E7 ADAPTOR CIRCUIT

for 874.4/51/52

DRAWN	PJL	ELAN DIGITAL	6/10/83
ISSUE	4	SYSTEMS LTD	
DRG. N°	27712

DRAWN P.J.L		ELAN DIGITAL SYSTEMS LTD	
ISSUE 4		6/10/83	
DRG. N° 2781/2

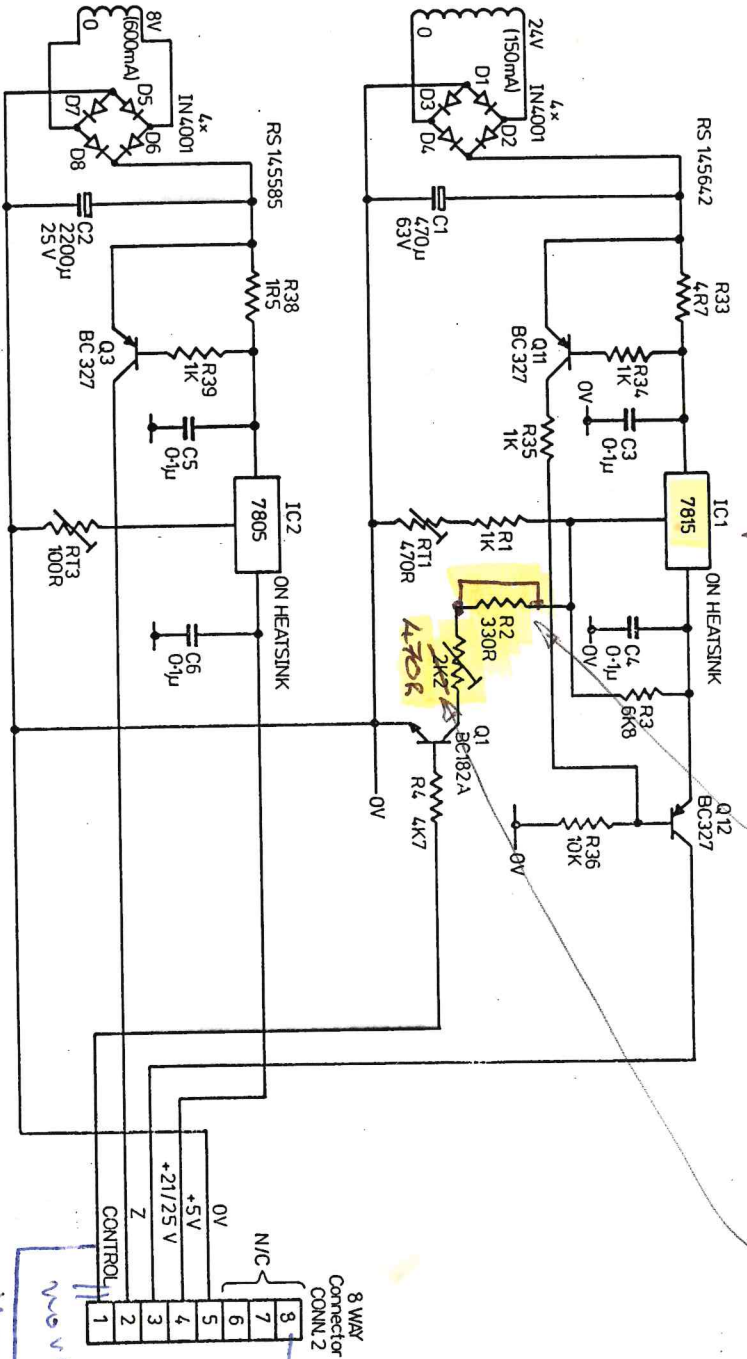
Isolate pin 1

Connect to Conn 1 pin 17

Connect to 8

ADAPTER P.S.U.

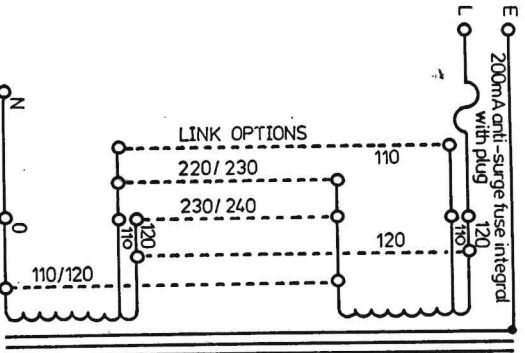
Change IC1 to 7812

Replace R2 with Link

Replace RT2 with 470R
